Approved Design Changes

Project: Villages of Garrison Creek-Phase IX

Approved Design Change A

Revision Description Revised Stormwater Plan and Details

UPDATED ROADSIDE SWALE TYPICAL SECTION

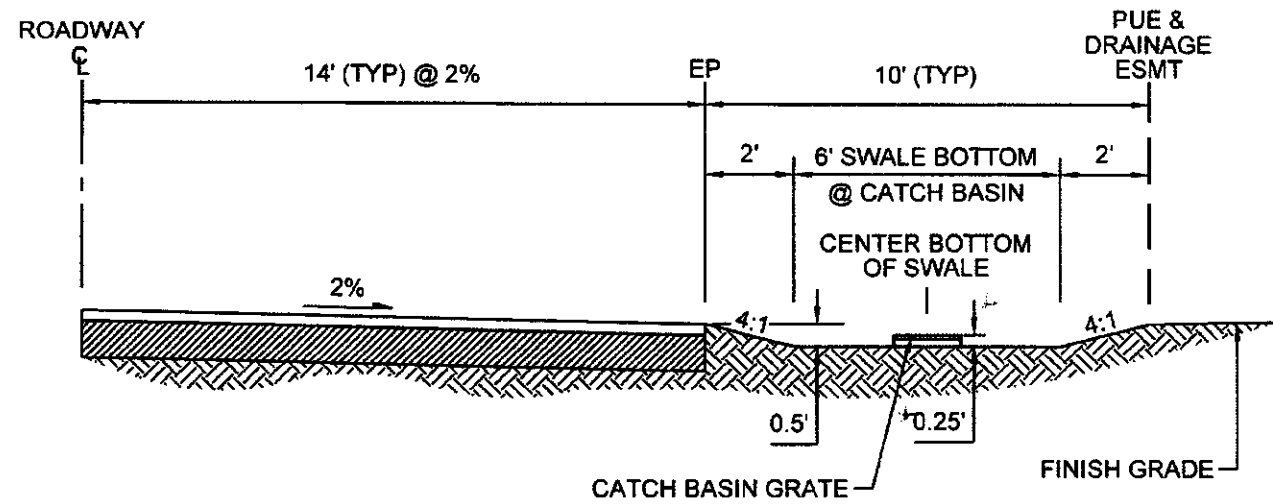
Handwritten notes below the title:
 * Swale width to be 6' to 8' based on
 amount of water to be collected
